**Final comments on the Ornithology Addendum
for the
Royal Society for the Protection of Birds**

**Submitted for Deadline 4
13 November 2021**

**Application by Alternative Use Boston Projects Limited for an
Order Granting Development Consent for the
Boston Alternative Energy Facility**

**Planning Inspectorate Ref: EN010095
Registration Identification Ref: 20028367**

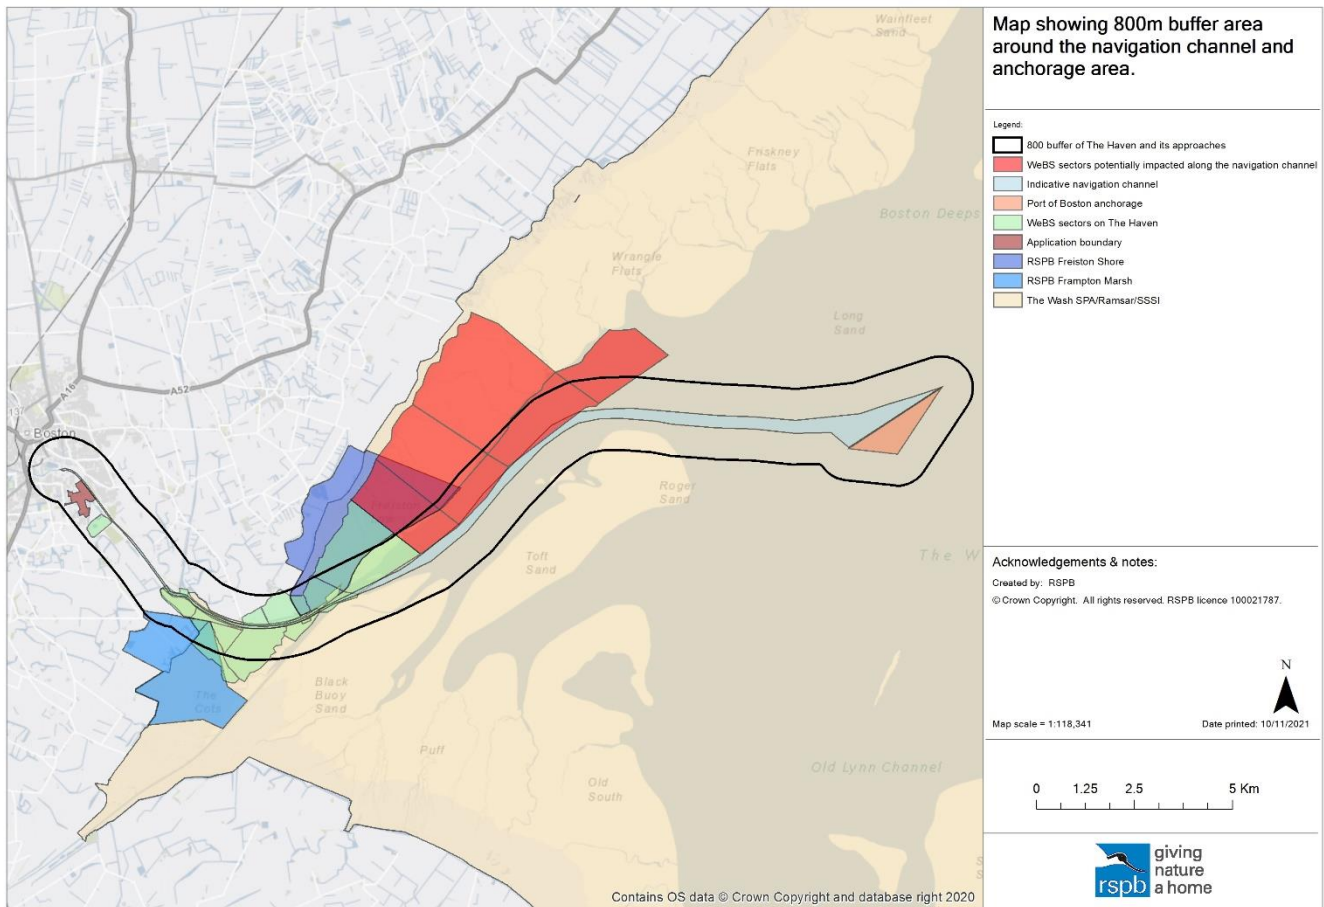
- 2.5 The Applicant's approach is one that suggests no disturbance could occur at any other point along The Haven or along the navigation channel out to the Port of Boston anchorage area. This is clearly an unrealistic scenario. Vessels have been shown to create disturbance to waterbirds as they approach The Haven from the anchorage area and along the navigation channel, as demonstrated by the Applicant's surveys. This disturbance will continue along the whole of The Haven as the vessels travel to the application site. However, no data has been collected by the Applicant to inform the actual abundance of these features along the navigation channel from the anchorage area to The Haven, their distribution, whether there are particularly important feeding and roosting locations, or any data on the effect of vessel movements along the navigation channel from the anchorage area to The Haven.

- 2.6 The Applicant's own data has shown disturbance from vessels as they approach the application site, with even small vessels having a greater impact than observed at the wider approaches to The Haven. The Applicant's own surveys have also recorded qualifying features of The Wash SPA/Ramsar that includes ringed plovers, dunlins, lapwings, turnstones, redshanks, oystercatchers, black-tailed godwits, bar-tailed godwits, curlews, grey plovers, cormorants, mallards, shelducks, black-headed gulls, herring gulls, lesser black-backed gulls and great black-backed gulls. This all provides evidence that these features are using The Haven. However, no data has been collected by the Applicant to inform the actual abundance of these features using The Haven, their distribution, whether there are particularly important feeding and roosting locations, or any data on the effect of vessel movements along The Haven.

- 2.7 Consequently, the potential area affected by the application is much greater than currently stated within the addendum and its appendix. Figure 1 shows the anchorage area and the navigation channel, with an 800m buffer. The Applicant's surveys have shown that birds may be displaced even further, with observations of up to 1000m on The Haven and 3300m from the mouth of The Haven. Whilst displacement distances inland from the navigation channel may be less, there is no data available to confirm this to be the case at this time. We consider such an area is needed to be considered in the HRA to ensure the full impacts of the application qualifying features of The Wash SPA/Ramsar are assessed.

- 3.11 This is an unrealistic approach as vessel movements occur along the whole of the navigation channel and as such will cause disturbance to waterbirds along the entire route. Whilst the actual scale of disturbance will vary from species to species, seasonally and even spatially along the navigation channel, no evidence has been collected to demonstrate an understanding of how qualifying features of The Wash SPA/Ramsar use The Haven and the navigation channel out to the anchorage area. A greater area should be used for the impact assessment such as that shown in Figure 1.

Figure 2: Map showing the area along The Haven where no existing data is known to exist on abundance and distribution of qualifying features of The Wash SPA/Ramsar. No data have been collected by the Applicant to determine waterbird abundance and distribution within this area.

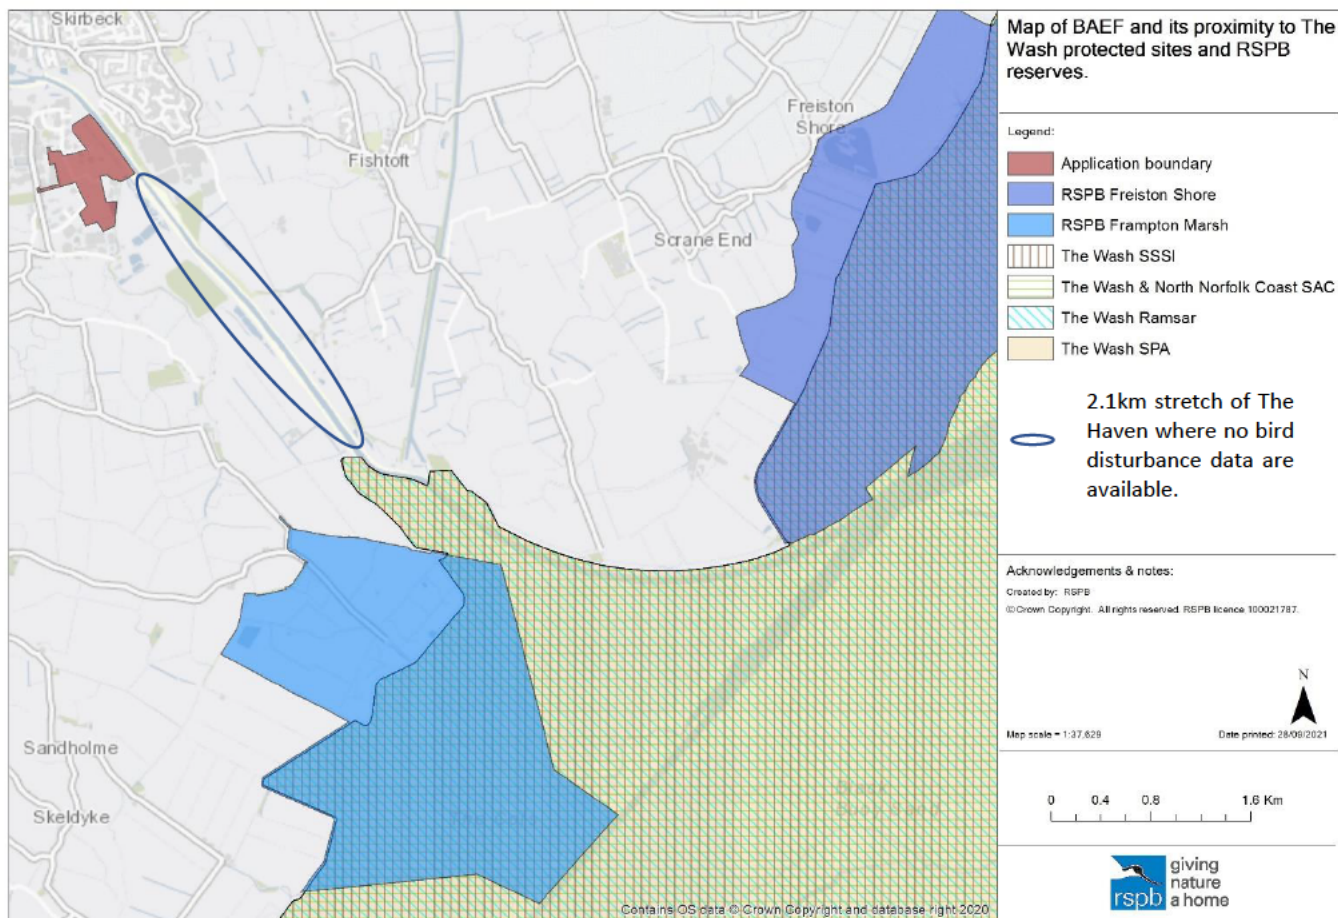
2.8 The Applicant has undertaken some limited ornithological surveys around the Application site and the mouth of The Haven. Whilst the Applicant has limited data for the area around the Application site, the mouth of The Haven, and now has WeBS data for the lower reaches of The Haven from Hobhole, there are no data available for a c.2.1km section of The Haven (Figure 2). Such data are needed to understand the full importance of The Haven for qualifying features of The Wash SPA/Ramsar/SSSI that will be foraging or roosting either within the channel or on adjacent banks. Disturbance from vessel movements will not just be confined to the areas for which data are available but continue along the whole of The Haven.

2.9 In addition, any surveys have focussed solely on the vessel movements along The Haven. There have been no assessments of recreational pressure or other activities that could be causing disturbance along The Haven. This is important to enable a full understanding of the cumulative and in combination pressure occurring as part of the baseline evidence. This additional information would help to identify:

2.10 These additional data are fundamental to understand the ecological consequences of the Application and drawing conclusions on qualifying features of The Wash SPA/Ramsar. However, to collect such data would require at least 12-24 months of further survey effort. We are therefore not aware that any appropriate data exists that would address the data. We do not consider these data gaps can be addressed during the Examination period as currently timetabled.

Figure 3: Map showing the location of behaviour surveys undertaken at Tabs Head looking out onto The Wash. The viewshed for surveyor is provided to show the limited area of the lower reaches of The Haven and the navigation channel that they will have been able to observe during the surveys.

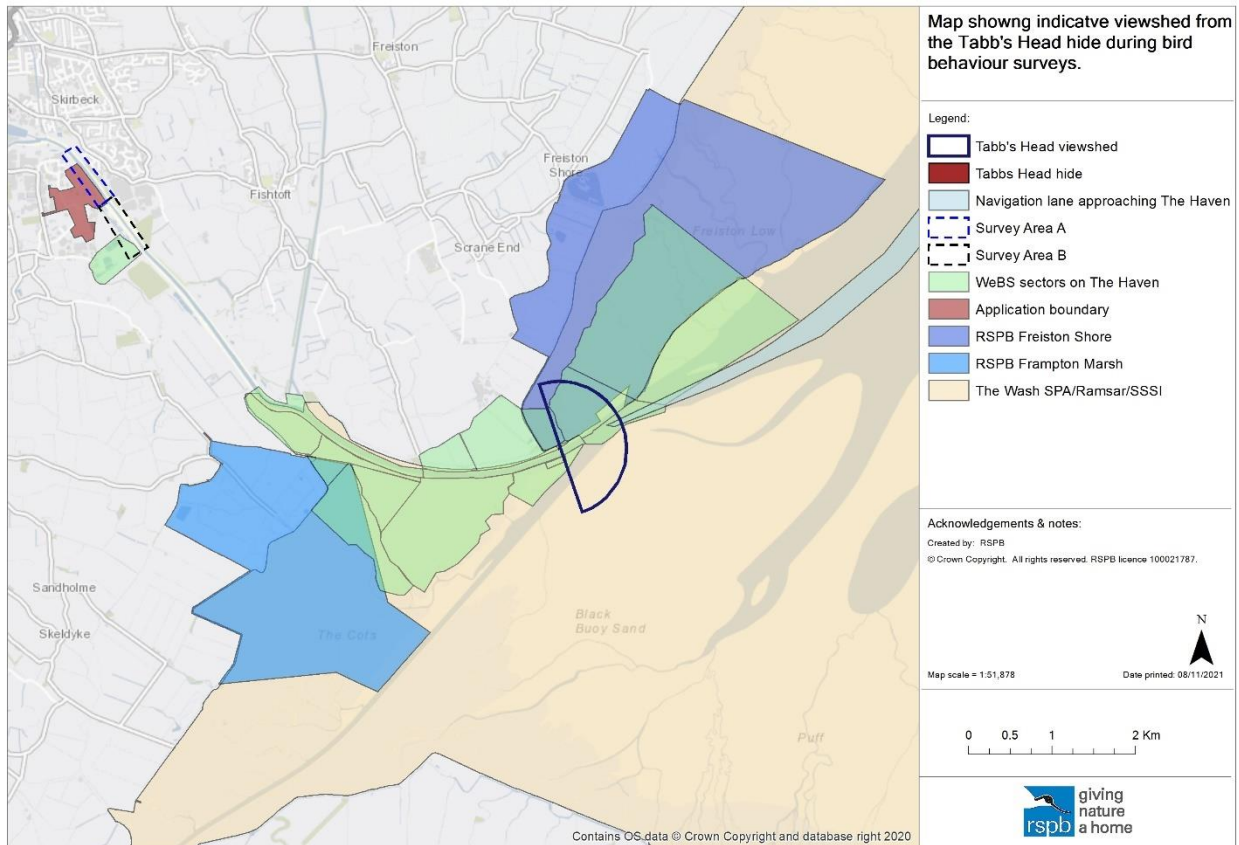
2.11 The surveys conducted at the mouth of The Haven have provided a helpful insight into the species that are present and their behaviour around the vessels using the channel. They demonstrate that the area is important for qualifying features of The Wash SPA/Ramsar and that disturbance occurs from the current vessel movements. However, we do not consider that they provide a full data set for assessing the impact of disturbance.

2.12 A specific limitation is that the surveys were conducted looking out onto The Wash from the hide at Tabs Head (Figure 3). This gives a 180° view onto The Wash. However, this does not allow for observations of vessel movements to be observed along The Haven. This is compounded by having only one surveyor carrying out the observations, as additional surveyors would be required to make observations in front and behind the hide. This means that the area of The Wash SPA/Ramsar up to Hobhole could not be observed during these surveys.

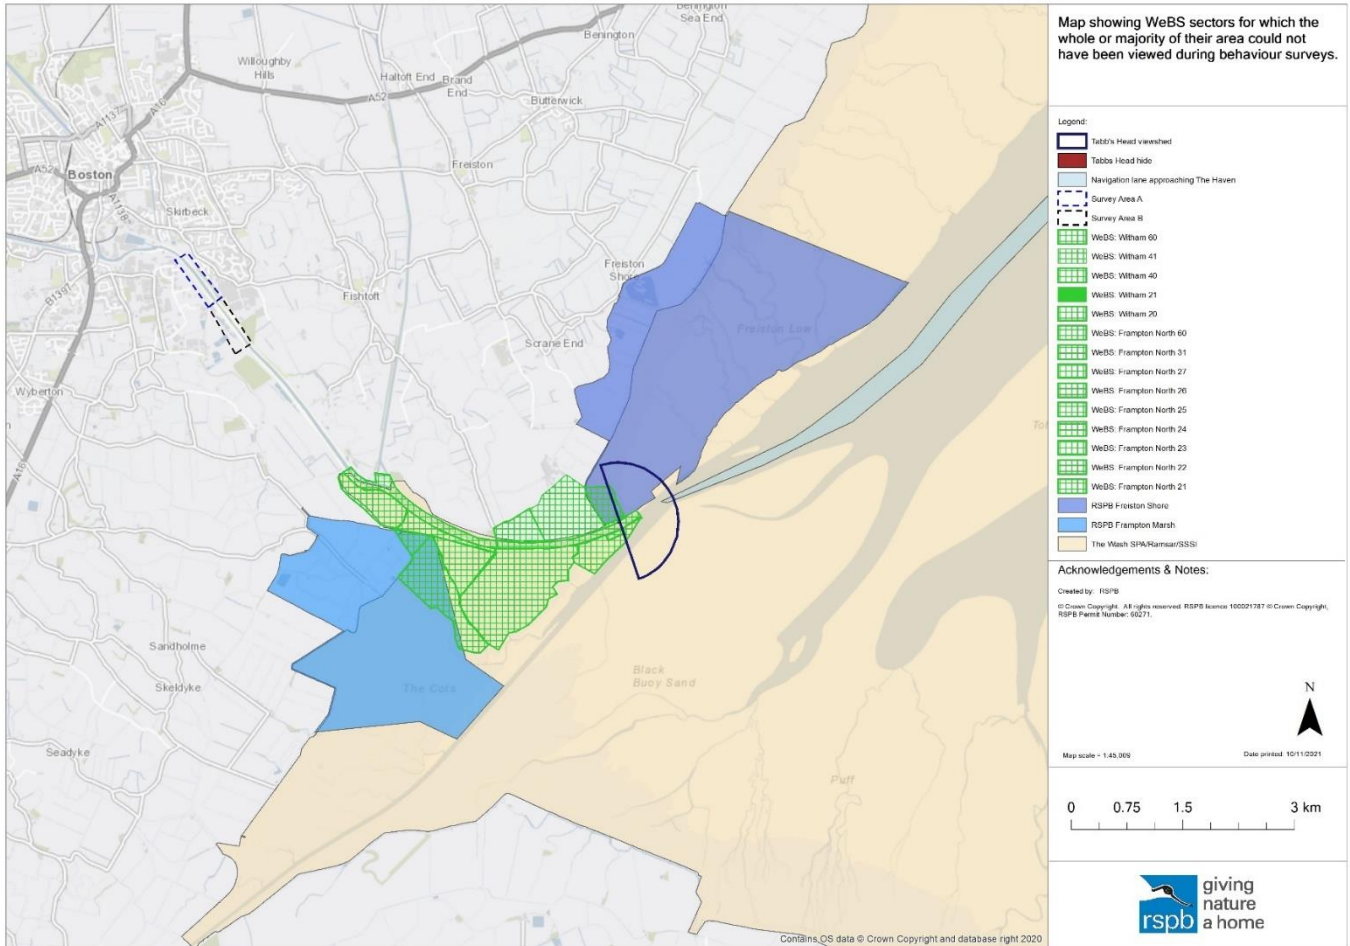
2.13 These are fundamental concerns with the survey approach given the number of sectors that support significant numbers of qualifying features of The Wash SPA/Ramsar, yet no data have been collected to understand the disturbance effect from vessels using the navigation channel through and past these sectors (Figure 4). Whilst the surveys provide useful information, they cannot provide a complete understanding of the effect of vessel movements on qualifying features of The Wash SPA/Ramsar. This is essential to ensure that all areas that could support qualifying features of The Wash SPA/Ramsar are fully understood to know where features roost and forage, the pressures that

they face along The Haven and out into The Wash, and how they respond to vessels and other disturbance pressures. It will not be possible to draw robust conclusions in the HRA where such evidence does not exist.

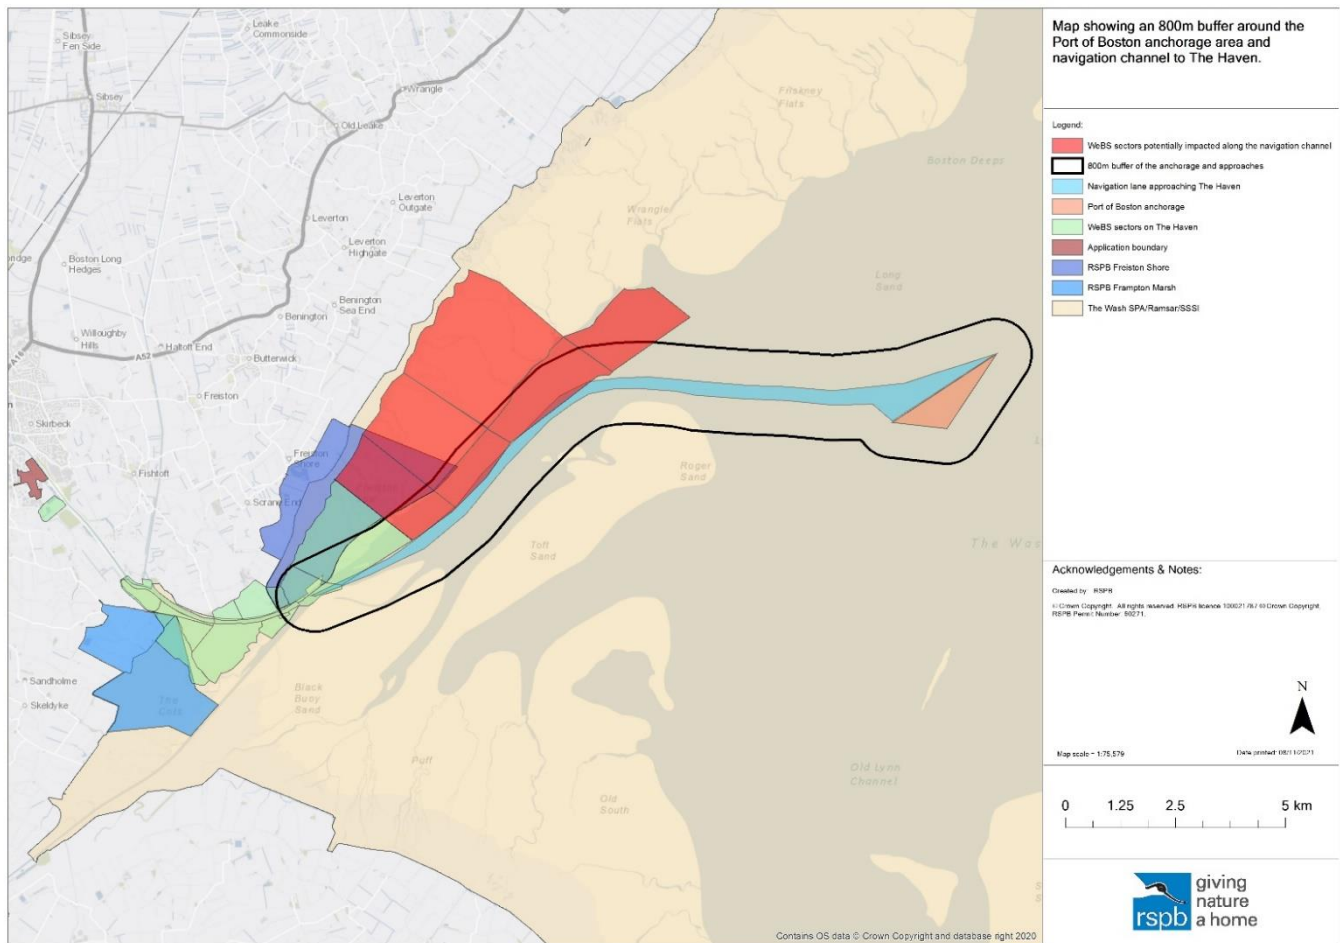
2.14 In our Written Representations, we have identified that there is a lack of data to identify the baseline disturbance levels to qualifying features of The Wash SPA/Ramsar around the Port of Boston anchorage area and the approaches to The Haven. The surveys conducted to date have only observed behaviour changes in waterbirds a relatively small area close to the mouth of The Haven. Figure 5 shows the indicative area of the anchorage area and the navigation channel used by vessels accessing or leaving The Haven. We have buffered it by 800m to be consistent with the observed displacement of birds at the mouth of The Haven to show the extent of the area for which no baseline data exists to rigorously assess the impact that current levels of vessel movements have within The Haven. This is important to assess the current impact that this activity is having on the abundance and distribution of qualifying features of The Wash SPA/Ramsar.

2.15 Figure 5 also identifies that there are additional WeBS sectors along the navigation channel leading to the anchorage area that could be impacted by disturbance from vessel movements. We recommend that the data for these additional WeBS sectors be obtained and included in revised assessments of potential impacts both of baseline activity and during construction and operation of the facility. The Sectors that need to be included are:

- Butterwick 30
- Butterwick 51
- Butterwick 31
- Butterwick 52
- Benington 30
- Benington 50
- Leverton 50
